REGIONAL REVIEW NOTIFICATION

ARC REVIEW CODE: R1906171

Name of Proposal: Austell Site (DRI 2964)

DRI 2964 (AUSTELL SITE) DRI
City of Austell
ARC Natural Resources Review Comments
June 12, 2019

DRI# 2964

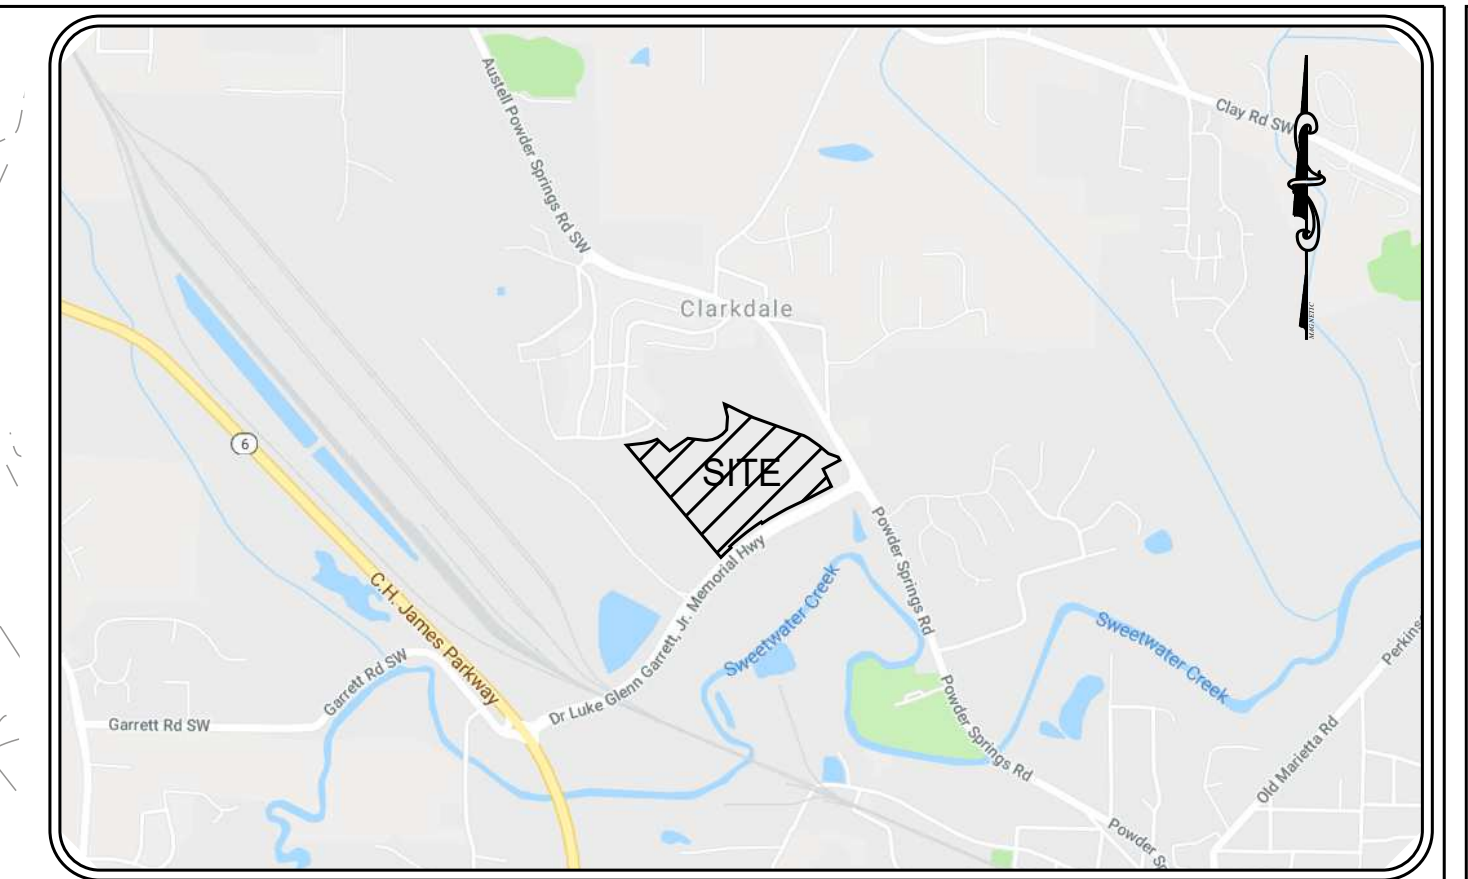
The USGS coverage for the project area and the submitted site plan show no perennial (blue line) streams on the property. Any unmapped streams on the property may be subject to the City of Austell's water supply watershed and citywide stream buffer ordinances. In addition, any unmapped streams on the property as well as any waters of the state are subject to the requirements of the State Erosion and Sedimentation Act, which includes a 25-foot buffer on all state waters.

The site plan identifies two (2) proposed driveway access points off Dr. Luke Glenn Garrett, Jr. Memorial Highway.

Access to adjacent parcels are provided by Dr. Luke Glenn Garrett, Jr. Memorial Highway, a local road.

The development offers two shared access points for vehicles and freight traffic.
